DRAWING NO. D212-664-247	TITLE CROSSTUBE ASS'Y (205 LOW AFT)	REV. B	<b>DART AEROSPACE LTD ENGINEERING ORDER</b>		D.E.O. NO. D212-664-247-B-1	SHEET NO. SHEET 1 OF 1	SCALE NTS
DRAWN <i>97</i>	CHECKED <i>ASS</i>	MFG. APPR. <i>AB</i>	APPROVED <i>WD</i>		DE APPR. <i>AB</i>		
DATE 11.07.15	DATE 11.07.20	DATE 11.07.21	DATE 11/07/21		DATE 11.07.21

**PURPOSE:**

REPLACE MAGNOBOND WITH PROSEAL.

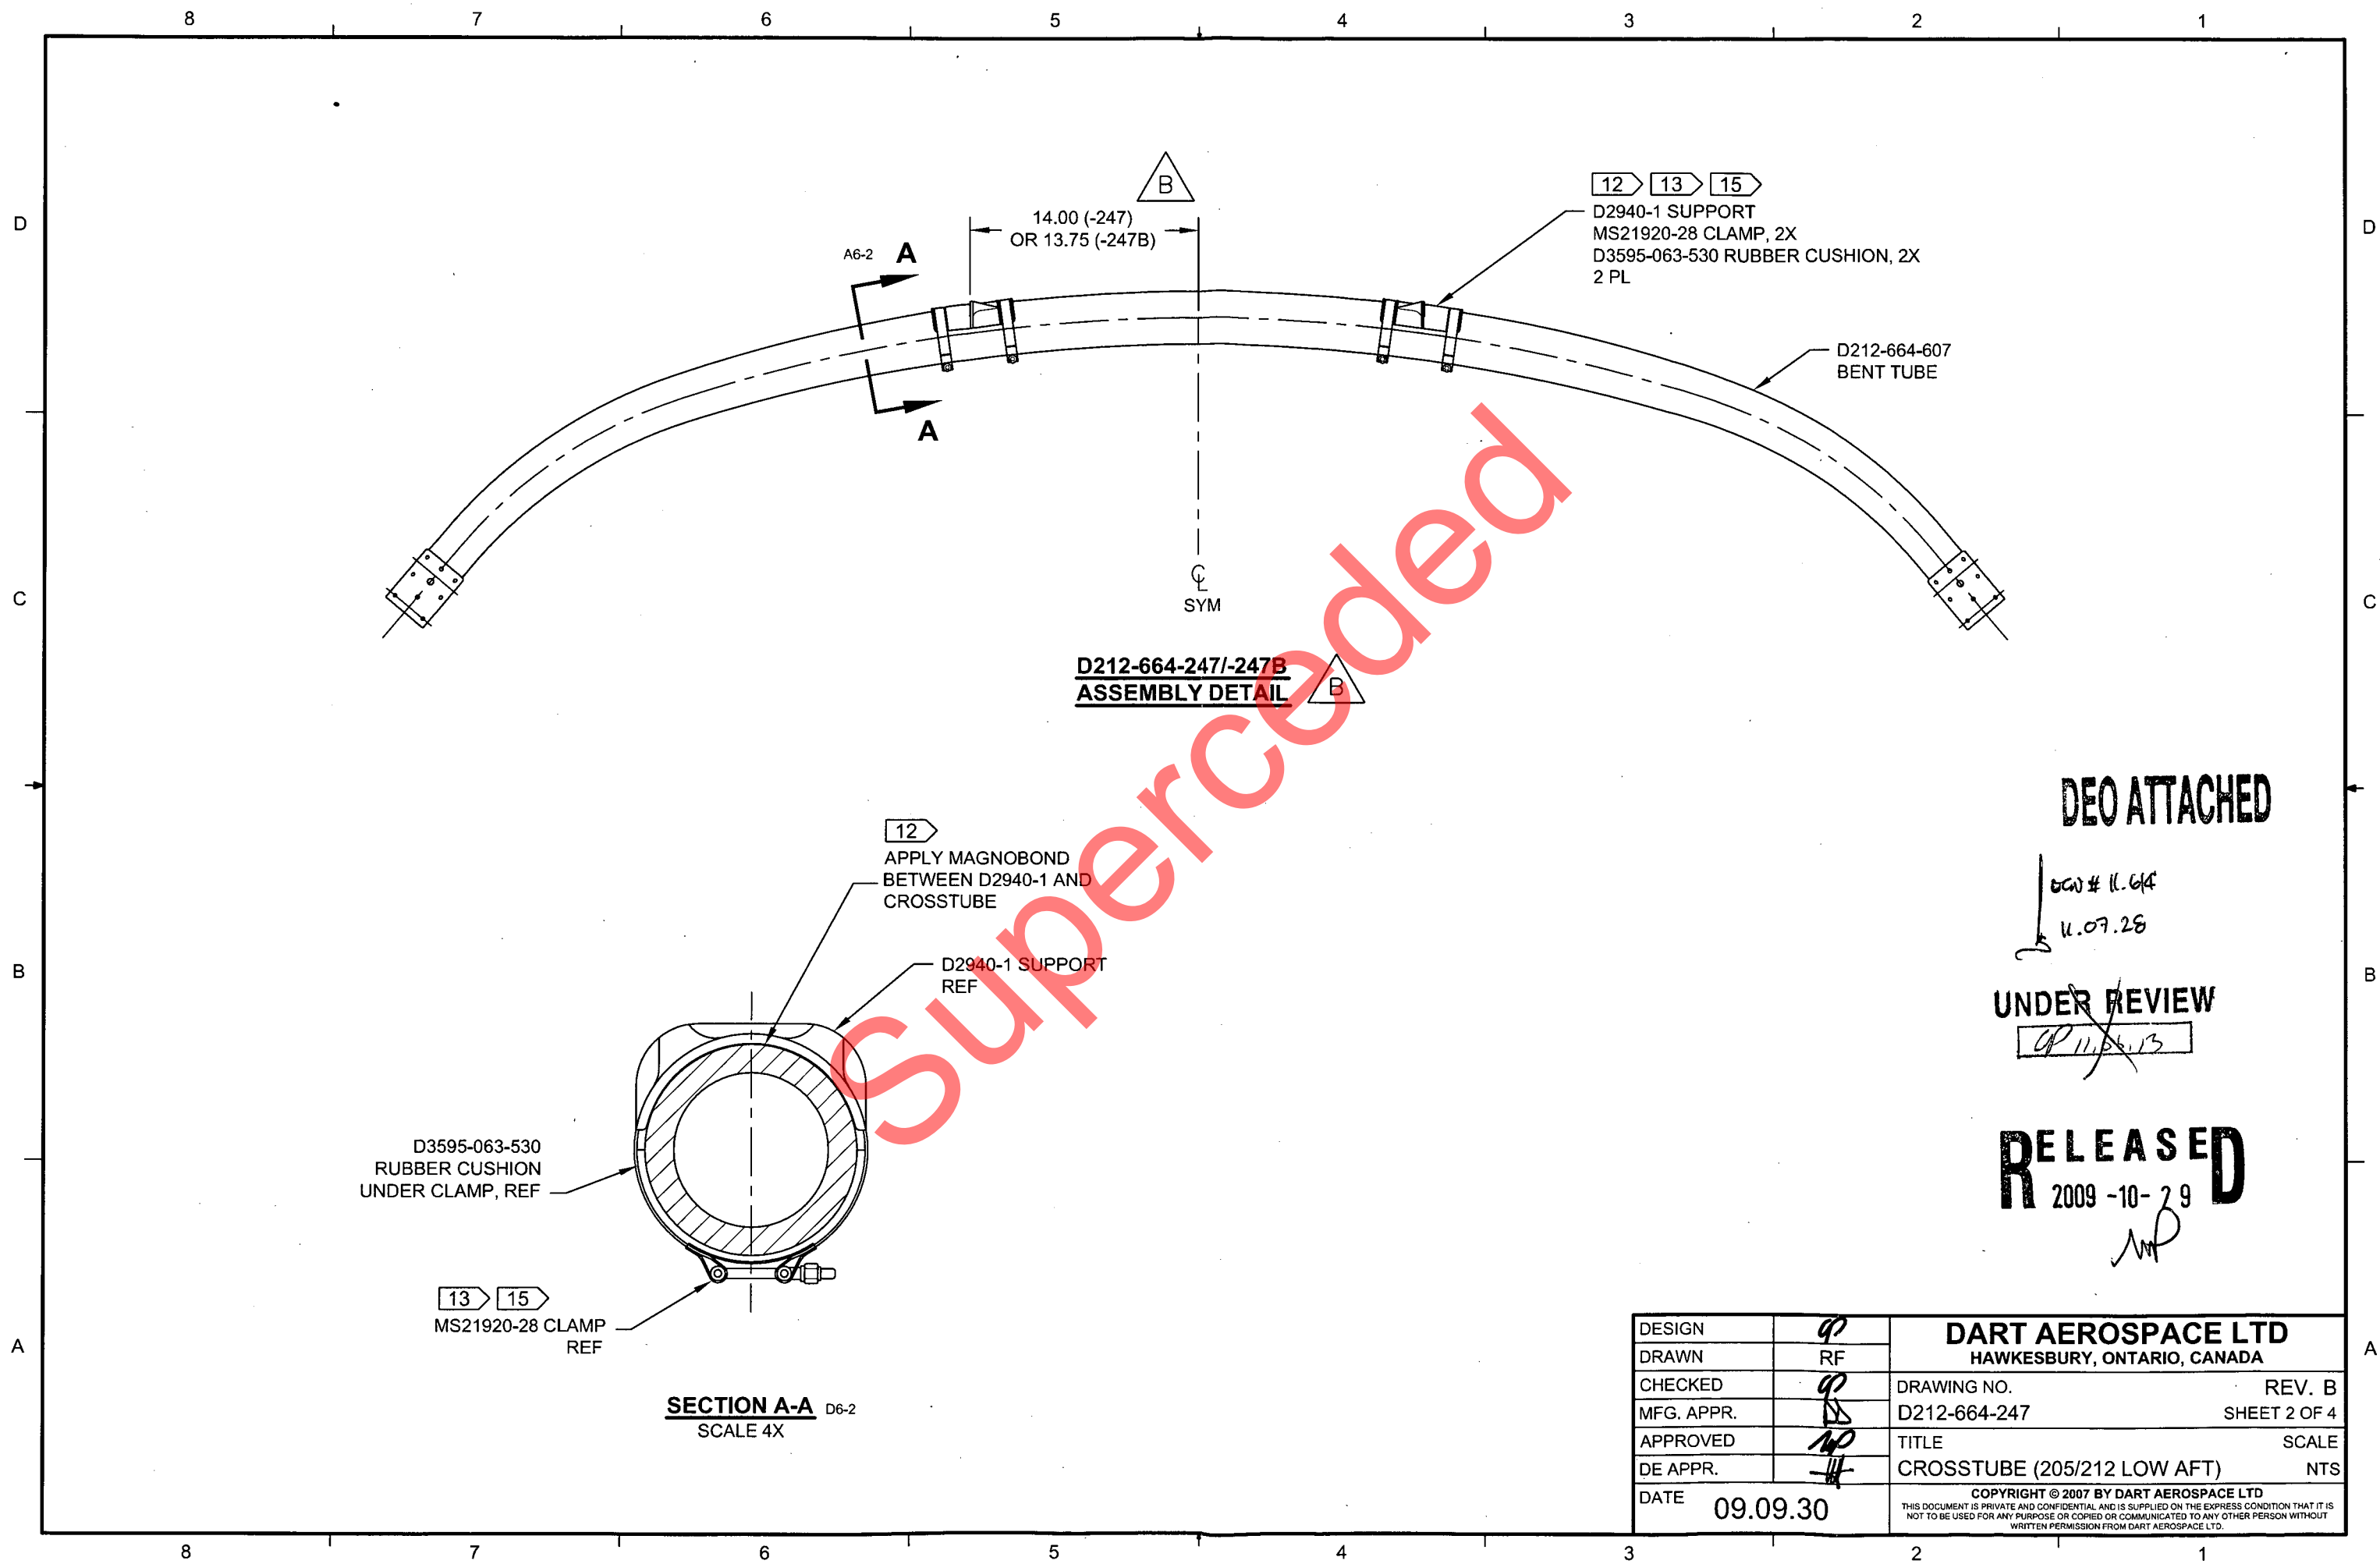
NOTE 12 & 15, SHEET 1 IS AMENDED AS FOLLOWS:

12) INSTALL D2940-1 SUPPORT USING 0.03" TO 0.06" THICK LAYER OF MAGNOBOND 6398 TO THE SURFACE OF D2940-1 THAT WILL BE IN CONTACT WITH THE CROSSTUBE PER QSI 015. LET CURE FOR 12 HOURS AFTER INSTALLATION AND PRIOR TO PACKAGING.

15) TORQUE CLAMPS 80 TO 100 IN-LB. ENSURE AT LEAST 1.5 THREADS SHOWING IN SAFETY AND THAT NUT HAS NOT BOTTOMED-OUT AFTER TORQUING.

Item	Qty -247	Qty -247B	Part Number	Description
9	A/R	A/R	PROSEAL 890 B-2	SEALANT, AMS-S-8802 CLASS B-2

12) TO INSTALL D2940-1 SUPPORT: ABRASE MATING SURFACE OF SUPPORT AND CROSSTUBE WITH 180-GRIT SANDPAPER AND REMOVE RESIDUE WITH MEK (OR EQUIVALENT). APPLY A 0.04" TO 0.07" THICK LAYER OF PROSEAL 890 CLASS B-2 (OR AMS-S-8802 CLASS B-2) SEALANT TO MATING SURFACE OF SUPPORT.

15) TORQUE CLAMPS 80 TO 100 IN-LB. ENSURE AT LEAST 1.5 THREADS SHOWING IN SAFETY AND THAT NUT HAS NOT BOTTOMED-OUT AFTER TORQUING. PRIOR TO PACKAGING, RE-CHECK TORQUE ON CLAMPS AFTER PROSEAL 890 SEALANT HAS CURED FOR 72 HOURS.
